ISSUE: Certificate of Appropriateness for alterations, an addition, and Waiver of Rooftop Mechanical Screening

LOCATION: Parker-Gray District
1310 Queen Street

STAFF RECOMMENDATION

BAR #2019-00480
1310 Queen Street

Figure 1: Old submission rear elevation to left; new submission to right - note the balance and symmetry

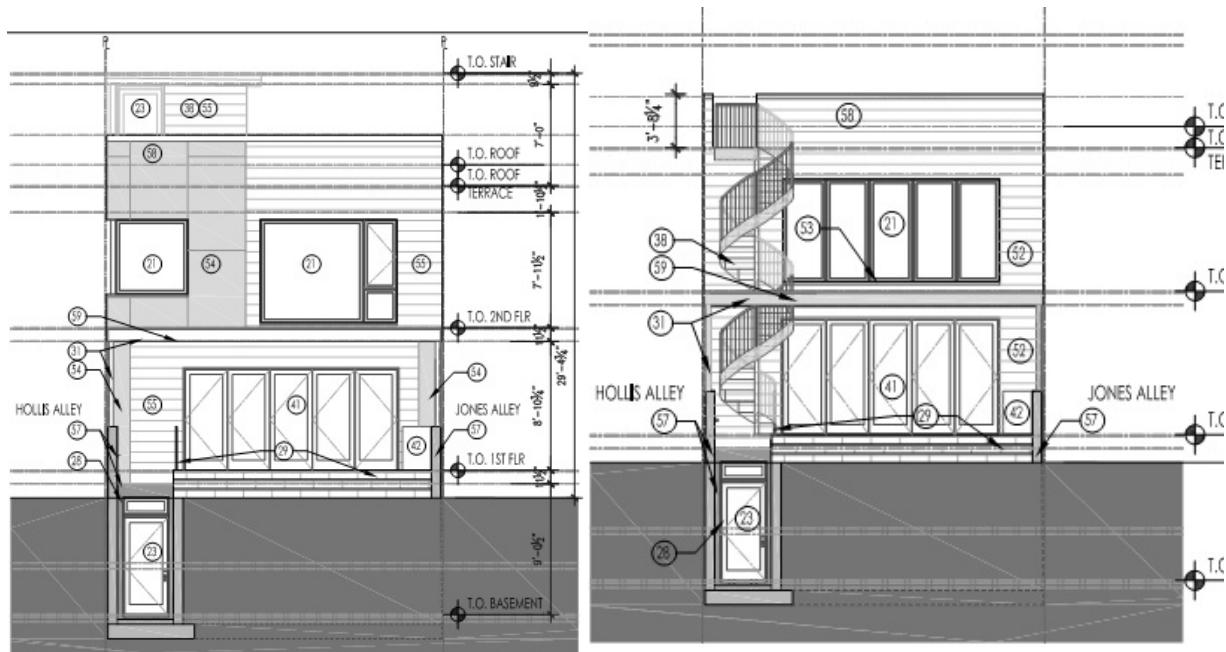
Figures 1-5 below show the other significant differences between the two applications and demonstrate that the applicant followed the Board's recommendations. The side and rear elevations are much simplified and more in keeping with the original house. The window fenestration is regular and balanced. Removing the rooftop stair enclosure addresses Board concerns regarding mass and height. Using both tempered glass and fiber cement panels on the parapet provides a degree of transparency and lightness to the roof deck. The rear spiral stair is unobtrusive and fits with the proposed design. Small hyphens on each side elevation create an appropriate transition between the old and the new.

Figure 3: New submission east elevation; note the regular window pattern on the addition and similarity of siding materials

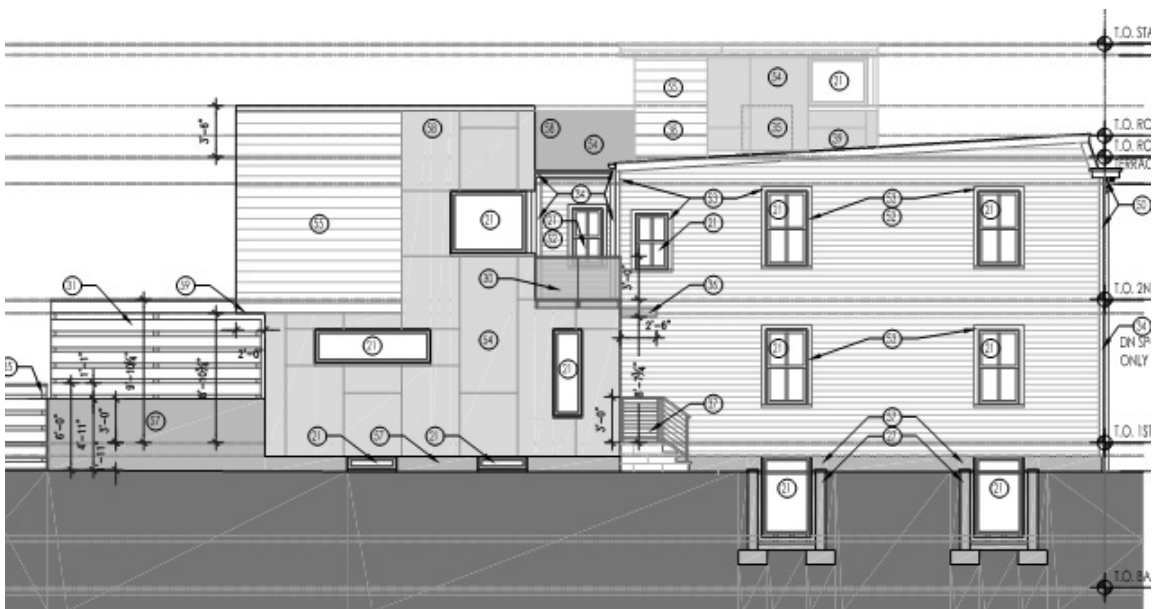
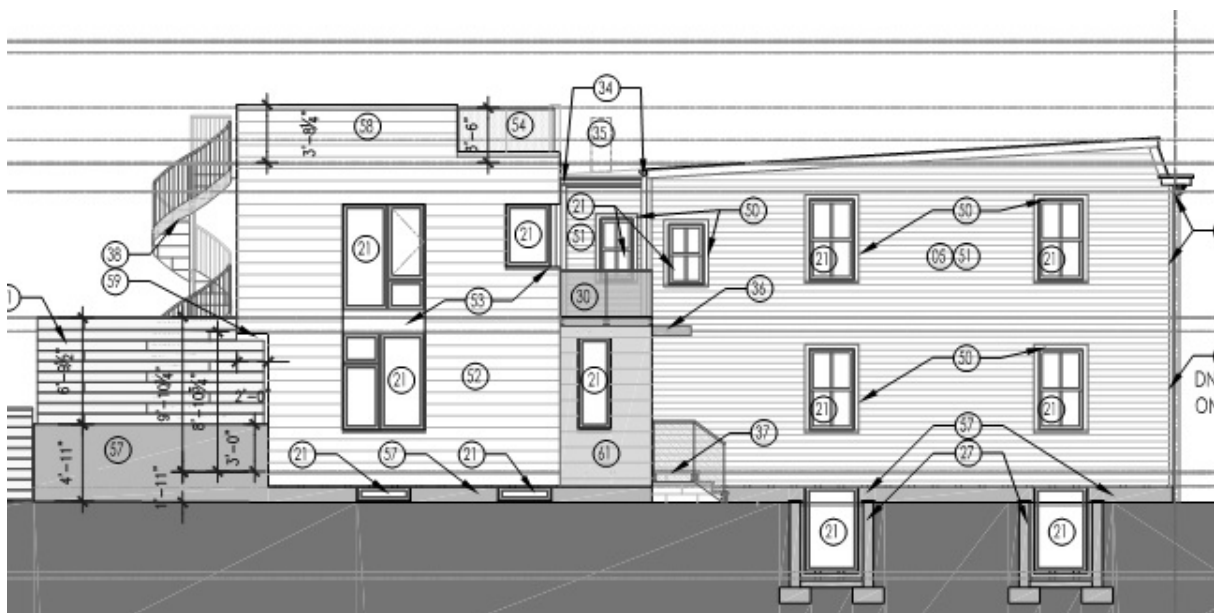
Figure 2: Original submission east elevation

Figure 5: New submission west elevation; note the smaller mass/size/height, regular window placement, and similarity in siding materials

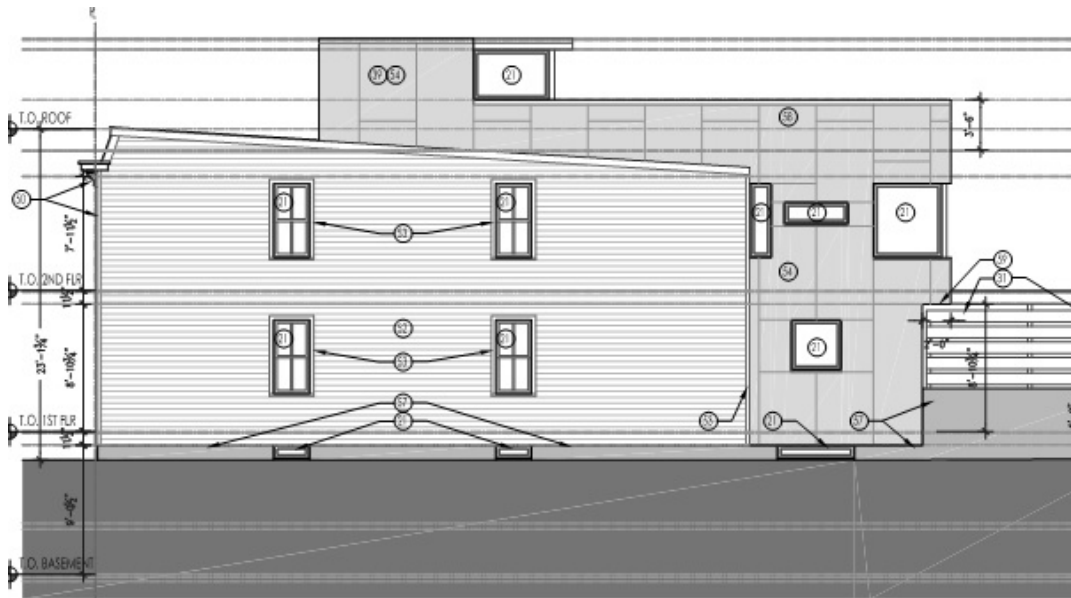
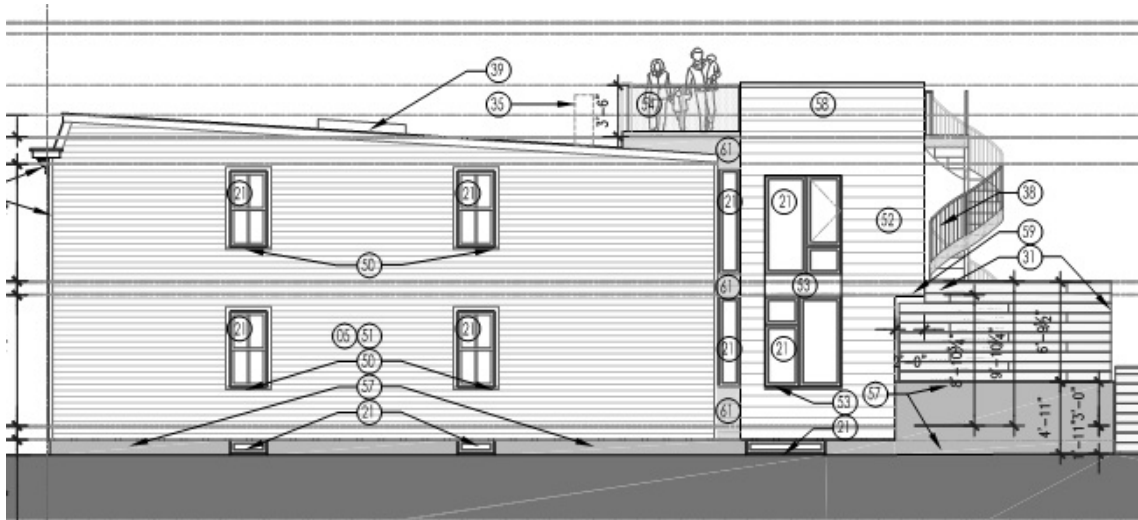
Figure 4: Original submission west elevation
